Errata Sheet

V 1.1, 2006-03

Device	**C505A-4E**
	C505CA-4E
Marking/Step	**Step CA**
Package	**P-MQFP-44**

CAN.4: Flowchart sequence in figure in User's Manual regarding Micro-controller handling of the Last Message Object is partly incorrect (C505CA only)

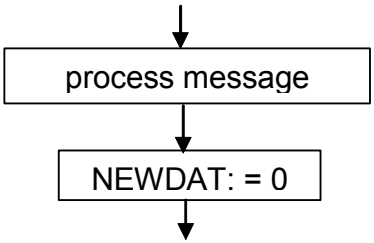
For the software flowchart figure 6-37 in User's Manual 08.97, the correct would be to first 'process message contents' and then to 'clear bit NEWDAT'.
